Direct Testimony

Jacob Pous

The Consumer Advocate of Newfoundland and Labrador

October 3, 2012

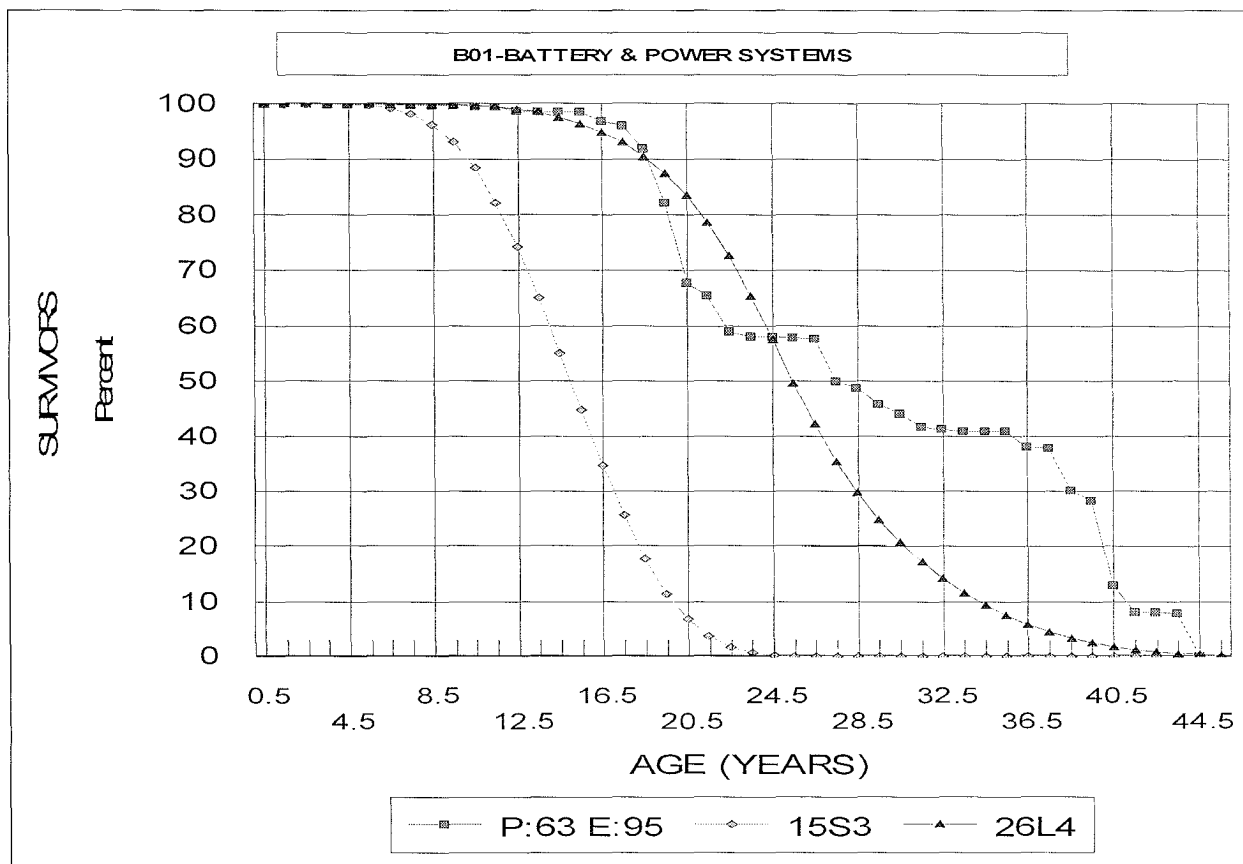
1 **Q. DO YOU AGREE WITH HYDRO’S PROPOSAL?**

2 A. No. I recommend a 23L4 life-curve combination.

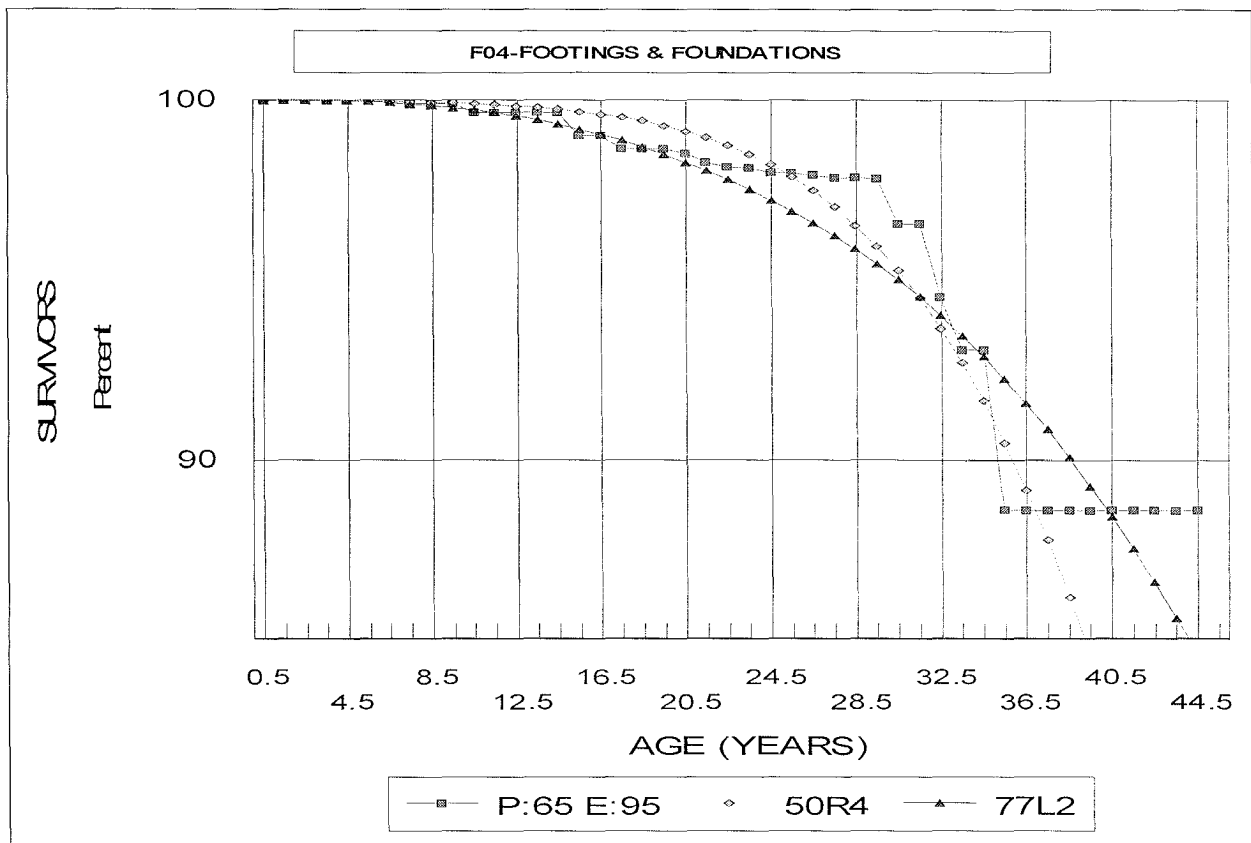
12 A. My recommendation also relies on actuarial results. However, it further recognizes the
13 type of investment in the account. In addition, it also recognizes that certain early
14 retirements may not be as representative of future expectations as Mr. Kennedy believes.

16 The investment in this account appears to consist of concrete foundations and concrete
17 pillars.⁴⁴ From this standpoint, one would expect a much longer ASL than 50 years. In
18 other words, it is reasonable to assume that a certain number of foundations may need to
19 be retired early due to less than typical retirement forces (e.g., premature closing of
20 facilities, or vehicles striking foundations or pillars, etc.) but realistic expectations are
21 that for the most part concrete foundations will last at least as long as the assets that
22 reside upon them. This understanding of the type of investment and its use would
23 normally yield a very long ASL.

25 Turning to actuarial analysis, the graph below compares Mr. Kennedy’s interpretation of
26 a 50R4 life-curve combination with a 77L2 life-curve combination. As can be seen on the
27 graph, a 77L2 life-curve combination is a superior fit through the first 22 years of age.
28 Mr. Kennedy’s interpretation is superior from about 23 years of age through about 30
29 years of age and again, for a few years around 34 to 36 years of age. However, at that

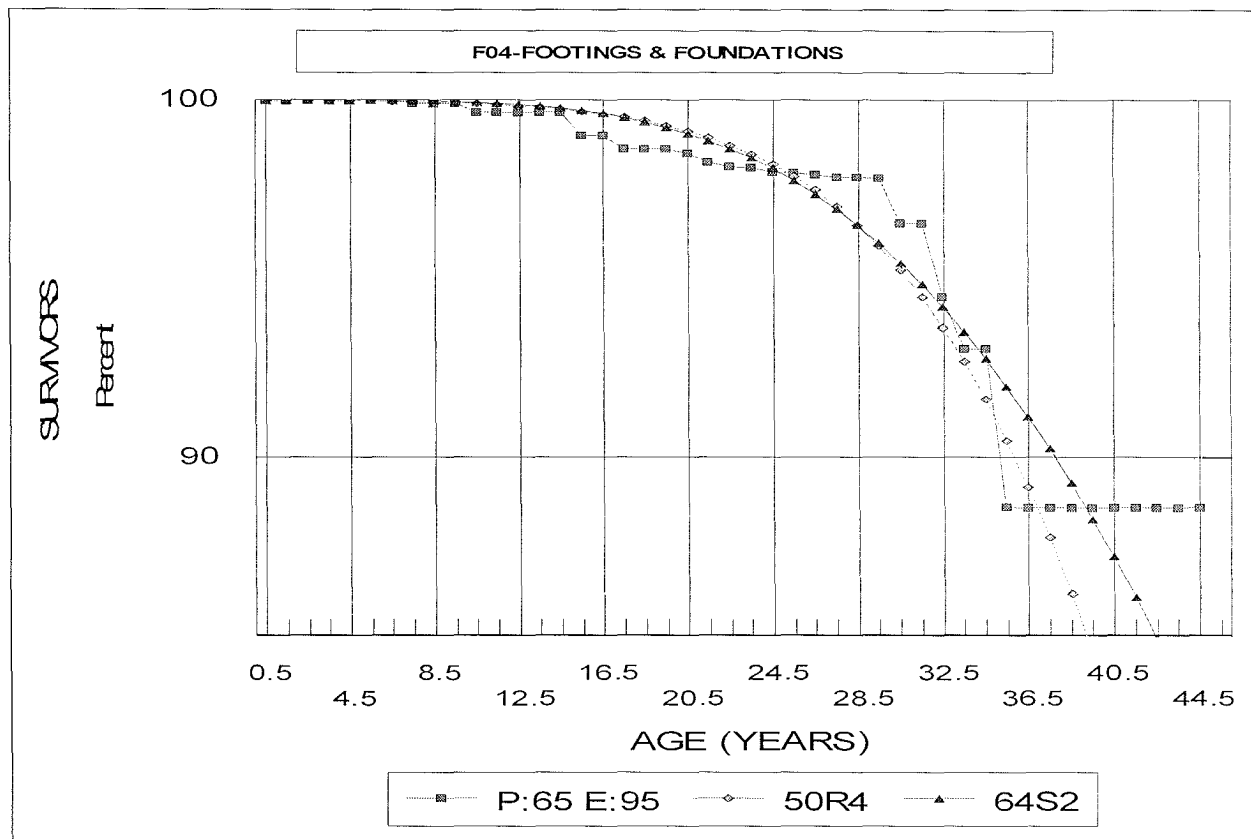
Another excellent curve fit corresponding to a 64S2 life-curve combination is set forth below. As can be seen in the graph below, Mr. Kennedy's interpretation and my recommendation are basically identical throughout the majority of the OLT. Mr. Kennedy's proposal begins to fall off swiftly at approximately 37 years of age and deviates from the OLT even though millions of dollars of plant exposures still exist through 42 years of age.

Given the curve-fittings for the two curves presented above, reliance entirely on actuarial results without proper consideration of the type of investment in the account and the potential for unusual retirement activity associated with the Roddickton Wood Chip Plant caused Mr. Kennedy to select an artificially short ASL. Alternatively, recognizing that concrete foundation and pillars normally can be expected to last 80, 90, or in excess of 100 years, should be taken into consideration when determining future life expectations. Indeed, Mr. Kennedy's 50R4 life-curve combination has a maximum life of approximately 75 years. In other words, for Mr. Kennedy's proposal to be realistic, it would have to be assumed that no concrete foundations or pillars could last more than 75 years. This is an unrealistic expectation.

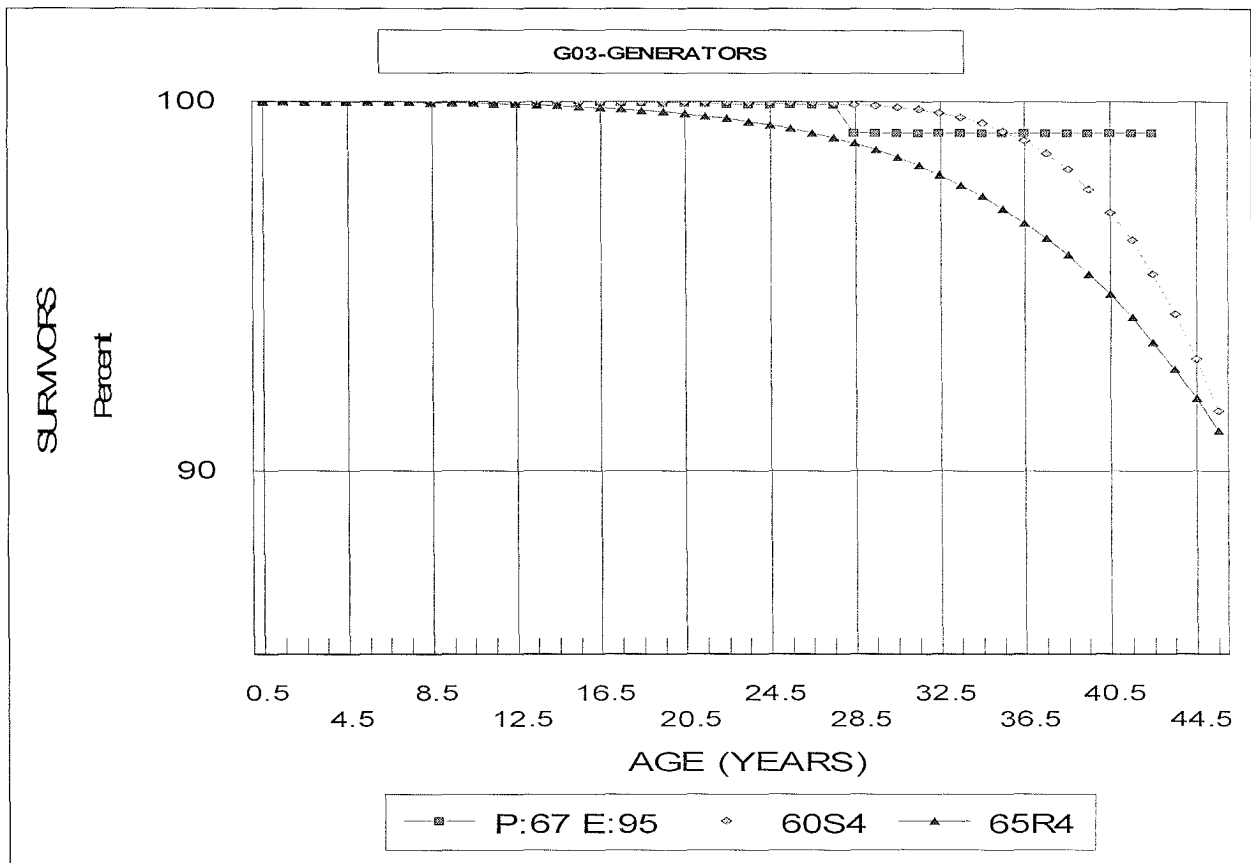
22 A. No. With the removal of generator windings, a longer ASL is warranted. I recommend a
23 conservative incremental step of 5 years corresponding to a 65R4 life-curve combination.

26 A. My recommendation reflects both a review of the results of actuarial analyses as well as
27 recognition of the remaining investment in this account. From a standpoint of actuarial
28 analysis, the only meaningful retirement reflected in Hydro's historical database is the

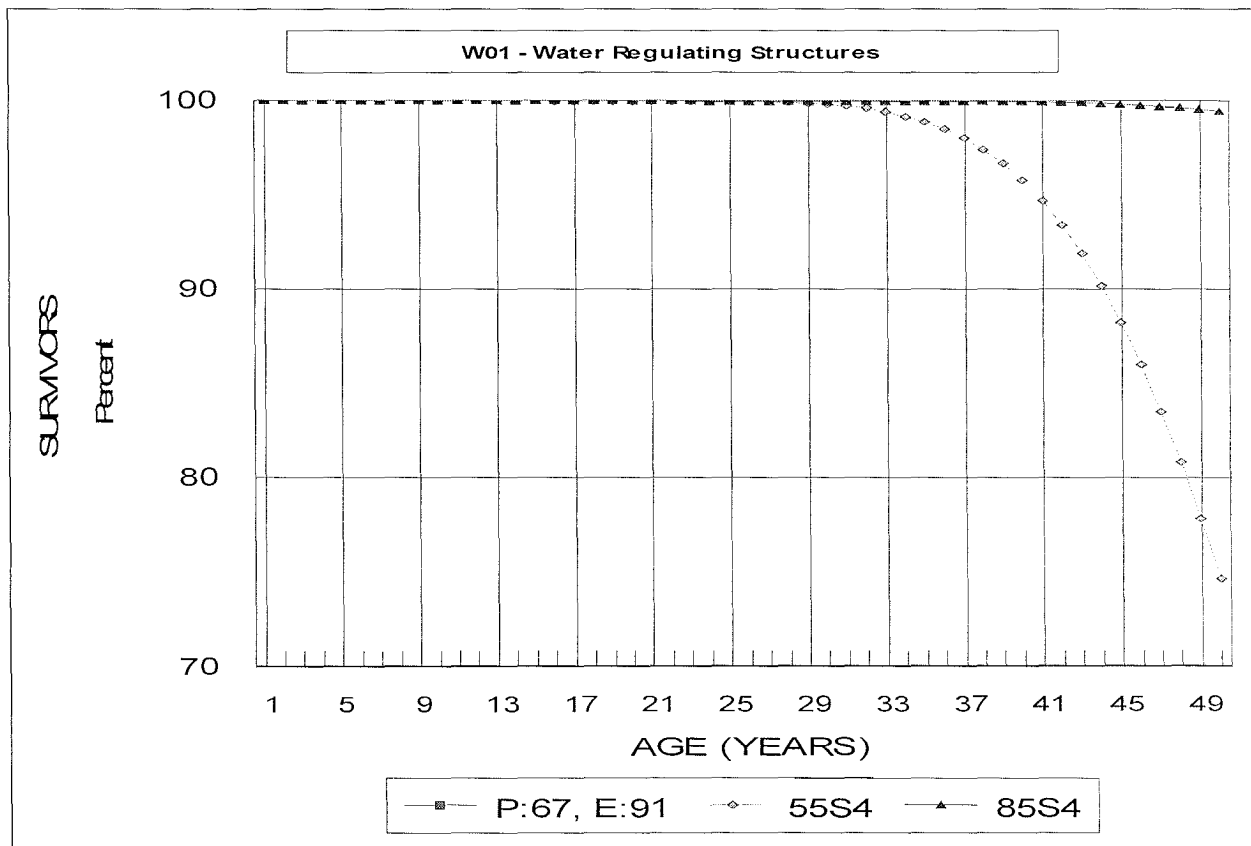
A. First, it is important to place the type of investment in this account in proper context. The majority of the investment in this account is associated with fish compensation structures as well as concrete spills and control structures.¹⁰⁴ In particular, some of the fish compensation structures are canals or channels designed to provide spawning and rearing habitats for fish. In other words, the majority of the investment in this account reflects very long-lived investments including those for which Hydro estimates 100-year ASLs.¹⁰⁵ Thus, from an internal consistency standpoint, a 55-year ASL is approximately half the life proposed by Hydro for other structures that perform the same or similar functions.

1 An 85S4 life-curve combination is also more in line with the 70- to 100-year estimate
2 that Gannett Fleming proposes for other peer companies.¹⁰⁶ Alternatively, Hydro's
3 proposed 55-year level falls well below the lower end of the peer group range.¹⁰⁷
4

5 Next, while there has been no retirement activity recorded for this account, an 85S4 life-
6 curve combination represents a better fit of the actual historical experience as shown in
7 the graph below. Indeed, based on Hydro's proposed life-curve combination and
8 recognition that the initial investment in the account was placed in service in 1967, one
9 would expect approximately 10% of the initial investment would have retired if Hydro's
10 proposal had merit. In other words, well over \$200,000 of retirement activity relating
11 solely to the 1967 investment should have already occurred were Hydro's proposal to be
12 reliable and have merit. Further, assuming no retirements have occurred through the
13 middle of 2012, then the 55S4 life-curve combination would have expected a 15% level
14 of retirements to the 1967 investment, but none have occurred.¹⁰⁸ Based on the fact that
15 there are no reported retirements for the investment in this account, Hydro's artificially
